Amendment to the Drawing

A replacement formal drawing is submitted consisting of FIGs 1, 2, 3, 4A, 4B, 4C, 5, 6A, and 6B on 9 sheets.

An amendment to the title is requested, replacing the title as filed in the subject application ("Hand-Held Stun Gun For Incapacitating A Human Target") with "Less Lethal Weapons And Methods For Halting Locomotion".

FIG. A

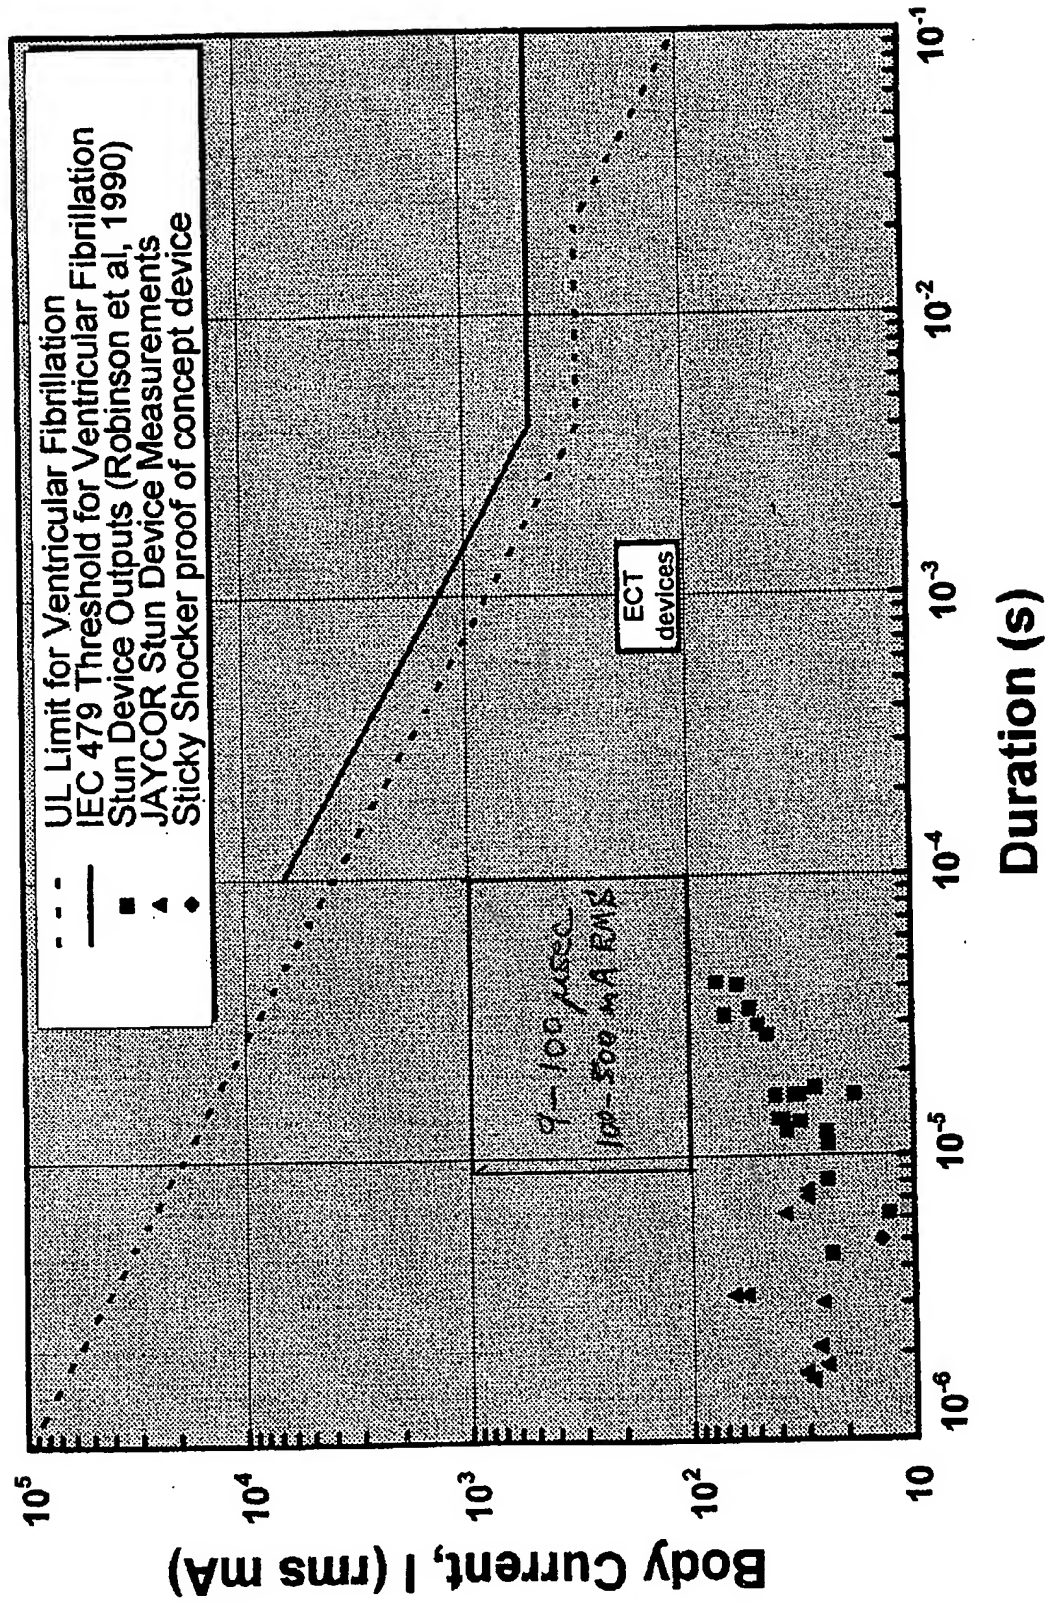
While *Jaycor* states “Short pulse durations (1-10 μ sec) appear to be effective at stimulating certain classes of nerve tissue, and generally are safer than longer pulses” (at page D-3) and states “All of the stun gun devices have an output consisting of a relatively low frequency (5 to 30 Hz) train of brief (1 to 40 μ sec) pulses” (at page D-8), those statements are not with reference to any one combination of pulse width and energy meeting the claim language recited in claims 13, 18, and 22. Those statements are merely gross summarizations of the details presented in Table 2 on page D-10.

Further, the data in Table 2 on page D-10 does not show any stun gun device output characteristic having an energy per pulse greater than 0.26 joules measured into a 1000 ohm load. Consequently, none of the devices in *Jaycor* are capable of the power output implied by the claims that recite pulse width in the range 9 to 100 microseconds in combination with energy

FIG. 1

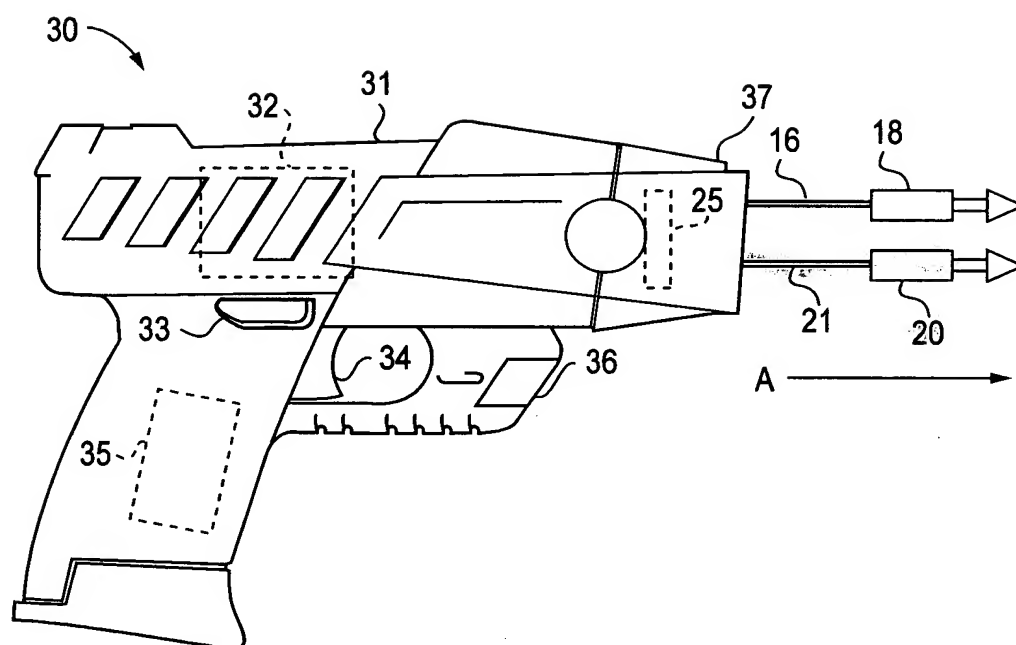
FIG. 1 of the amended drawing is the same as FIG. 1 of the originally filed drawing and shows a second dart 20 and wire 21. Support for a second dart and wire is found, *inter alia*, at originally filed FIG. 2 of the present application and in the originally filed text such as at paragraph [0029] and [0030] of the marked up version of the substitute specification. No new matter is submitted in the amended FIG. 1.

FIG. 2

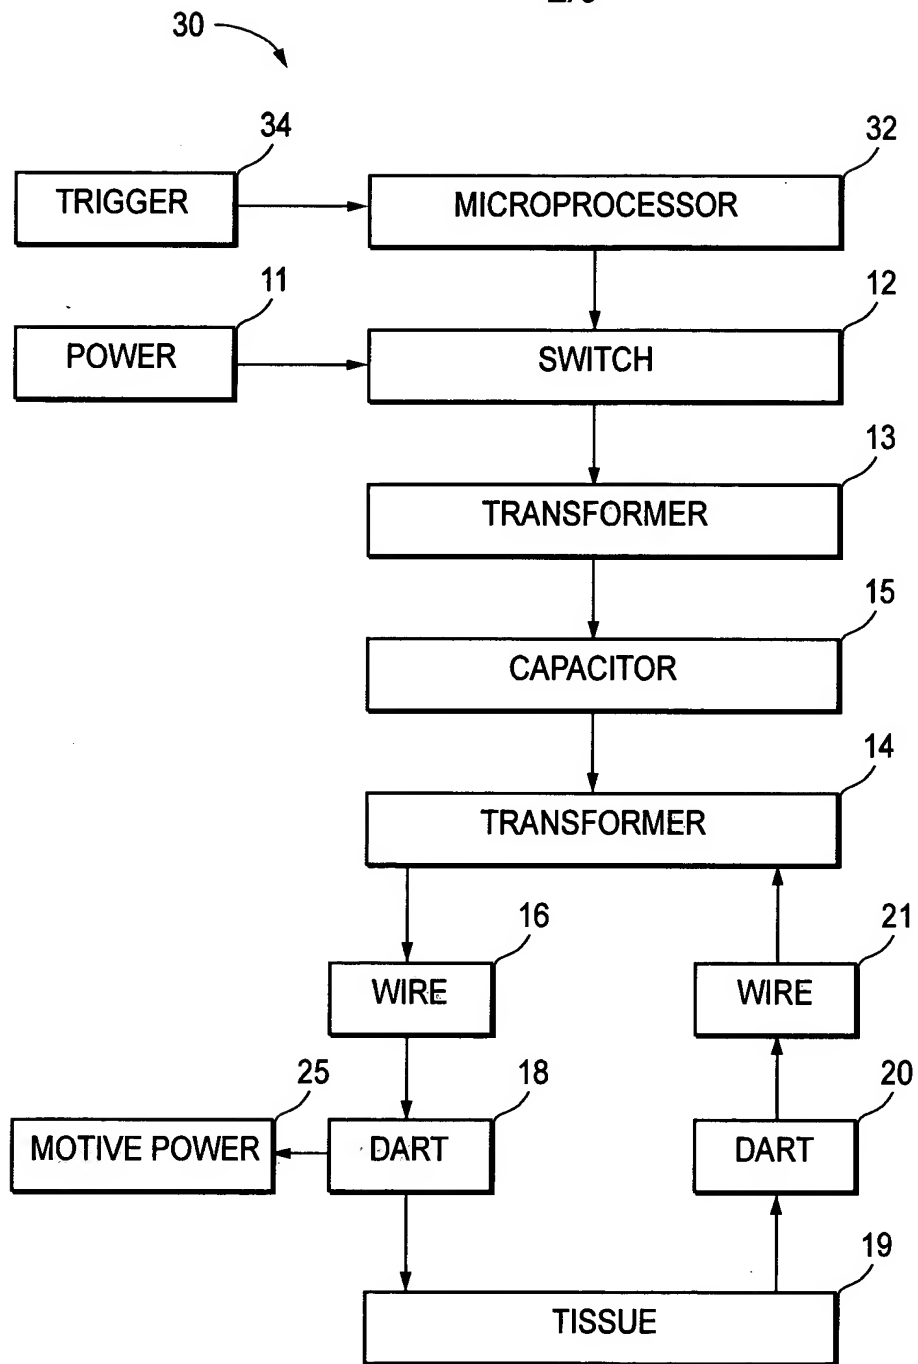
FIG. 2 of the amended drawing is an amended version of originally filed FIG. 2 of the present application. Non-uniform signal flow is corrected.

The relationship between wire 21 and transformer 14 is corrected. Support for FIG. 2 of the amended drawing is found, *inter alia*, at originally filed FIG. 2 of the present application and in the originally filed text such as at paragraphs of the marked up version of the substitute specification [0021] line 5, [0022] lines 4-5, [0023] lines 6-7, [0024] lines 5-6, [0025] lines 3-6, [0026] lines 4-5, and [0027] lines 4-5 each stating “a second conducting unit for transmitting electrical energy from the target to the apparatus” and in the originally filed claims. It is error to show on a block flow diagram the relationship between transformer 14 and wire 21 with reference to a “ground” of the weapon. Such a presentation may be appropriate for an electrical circuit schematic diagram, but is incorrect for a block flow diagram. FIG. 2 of the originally filed drawing and of the amended drawing is a block flow diagram, not an electrical schematic diagram. The “electrical energy” “transmitted” by wire 21 to “the apparatus” must complete a circuit with transformer 14 or the function of transformer 14 to step up the voltage of pulses from capacitor 14 cannot be accomplished. The correction is obvious from the type of diagram and no alternate presentation that is consistent with the text is possible. No new matter is submitted.

FIG. 4A

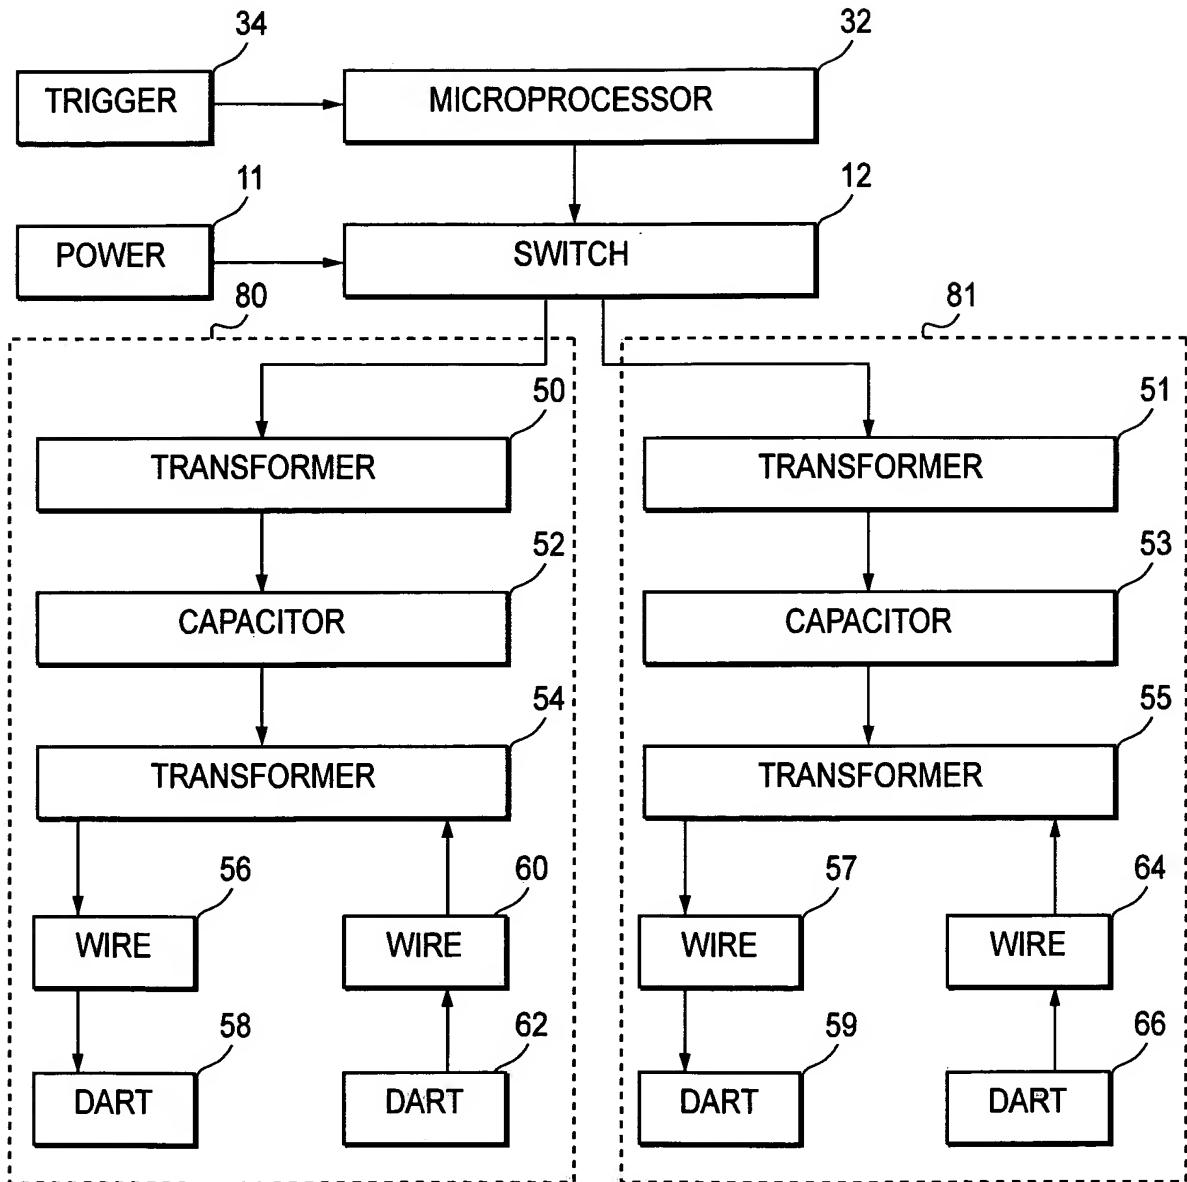
FIGs. 4A, 4B, and 4C replace originally filed FIG. 3 and find support, *inter alia*, for example in originally filed FIG. 3 taken with the text of paragraphs [0041] through [0050] of the marked up version of the substitute specification. The functional blocks and relationships shown in FIGs. 4A, 4B, and 4C are as described in the priority application and the present application as filed. No new matter is submitted.

Paragraph [0042] of the marked up version of the substitute specification finds support, *inter alia*, in deleted paragraph [0041] and refers to FIG. 4A of the amended drawing. No new matter is added.

FIG. 4B

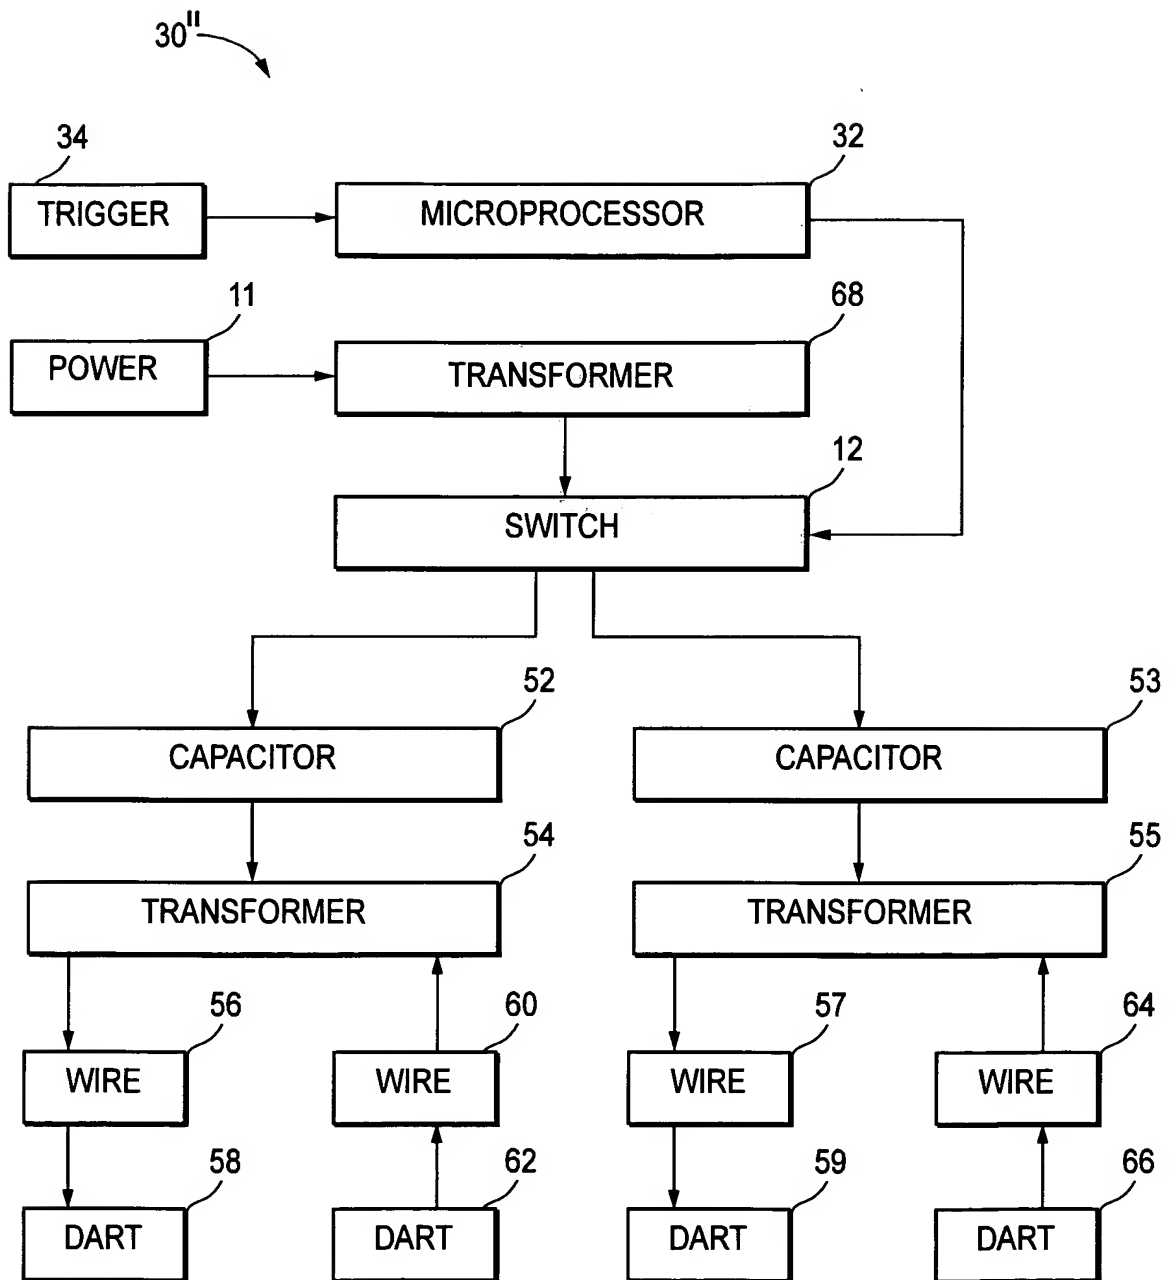
Paragraph [0048] of the marked up version of the substitute specification finds support, *inter alia*, in deleted paragraph [0047] and refers to FIG. 4B of the amended drawing. No new matter is added.

FIG. 4C

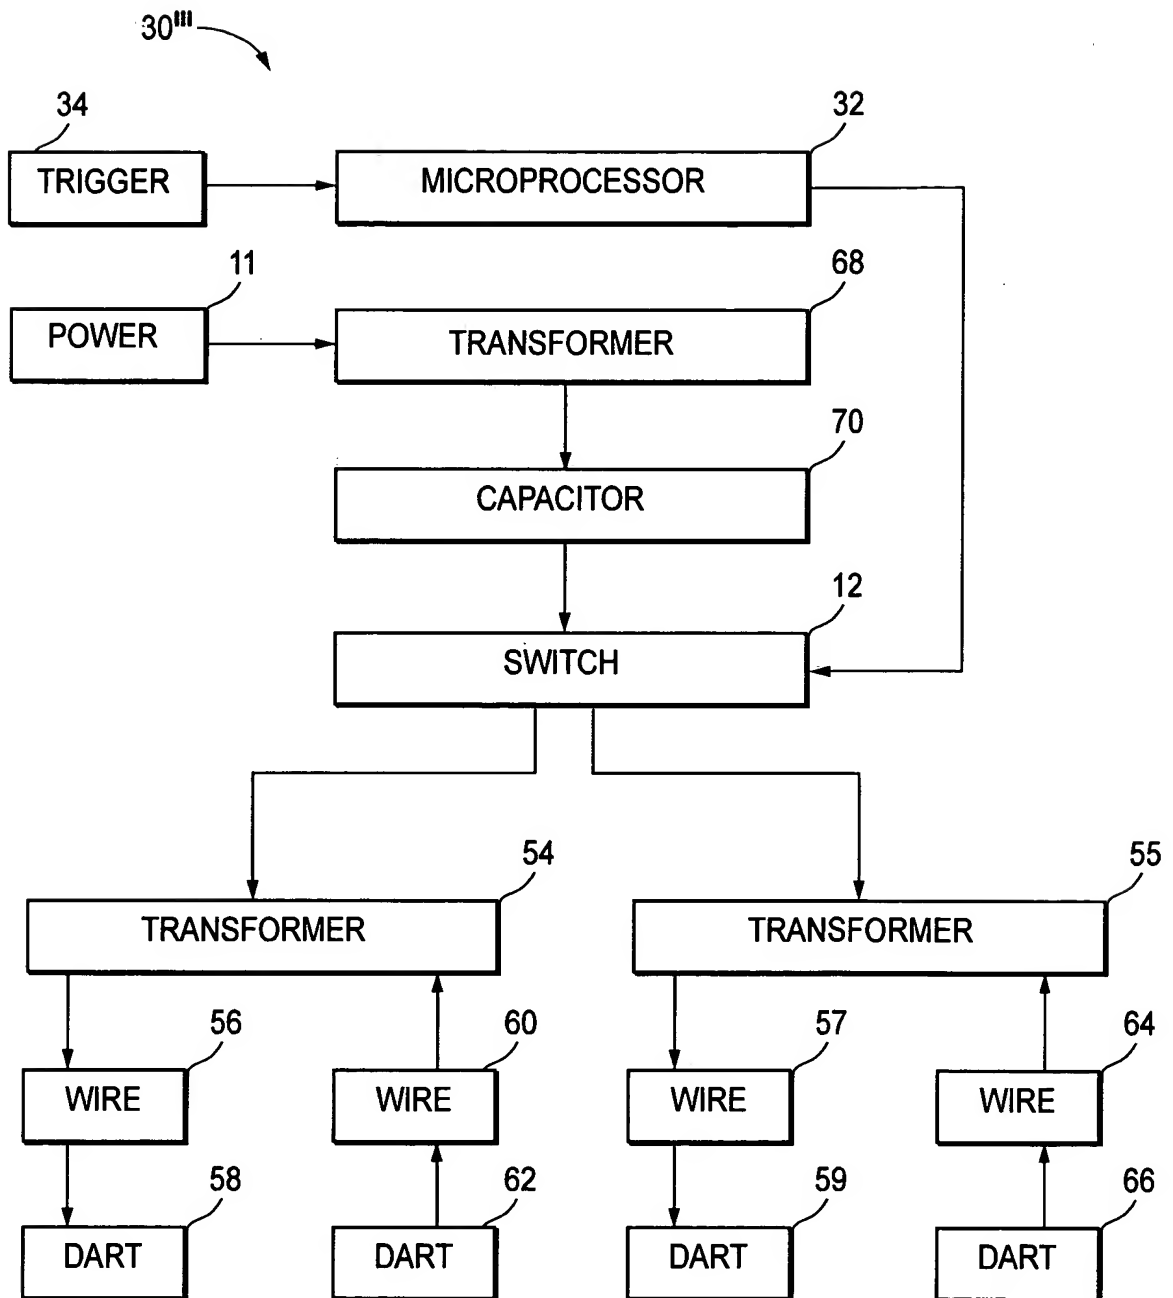
Paragraph [0050] of the marked up version of the substitute specification finds support, *inter alia*, in deleted paragraph [0049] and refers to FIG. 4C of the amended drawing. No new matter is added.

FIG. 5
(PRIOR ART)

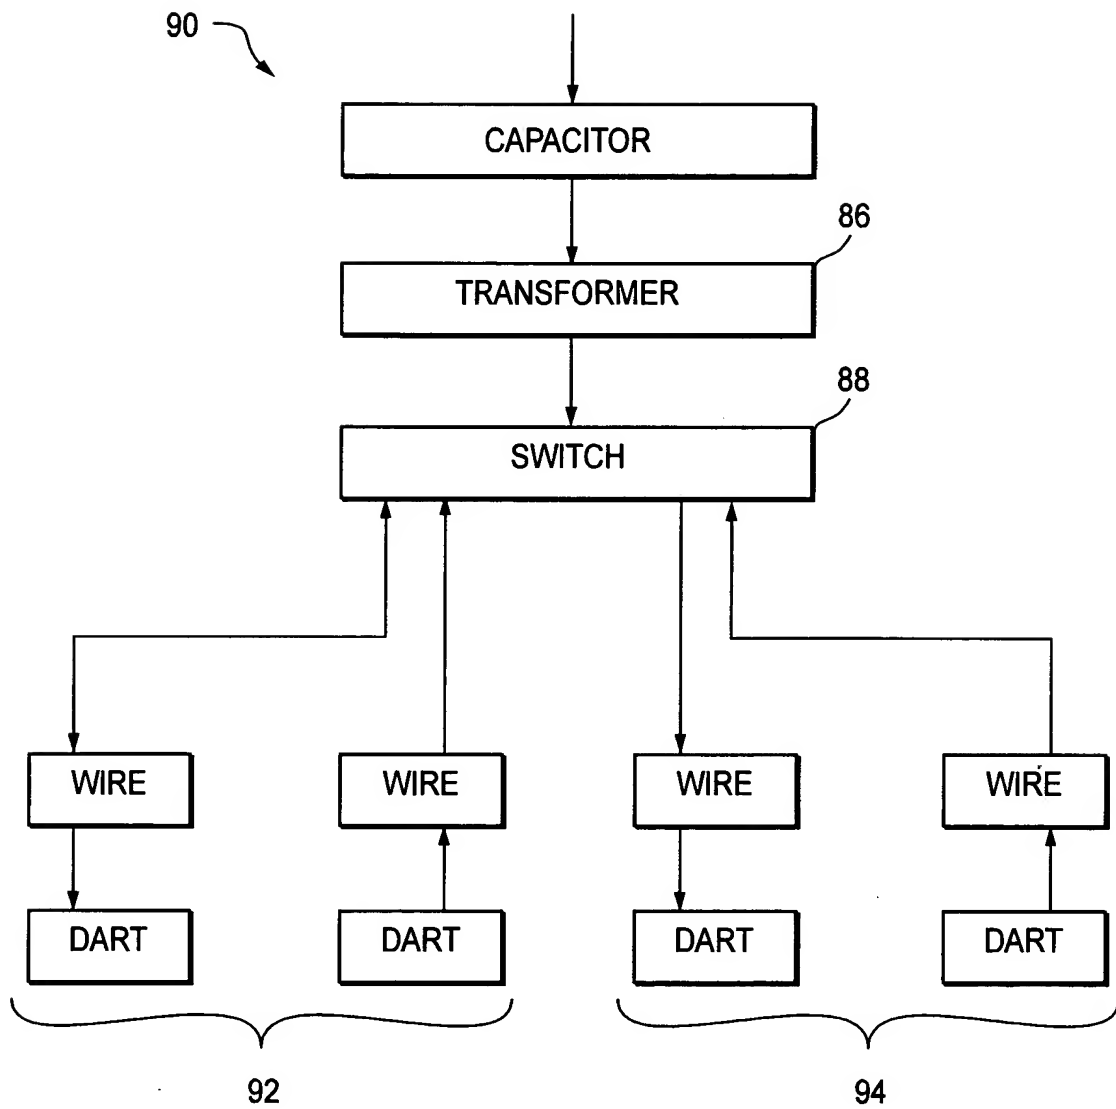
FIG. 5 (Prior Art) aid in understanding paragraph [0051] of the marked up version of the substitute specification. That paragraph admits a drawing. No new matter is submitted.
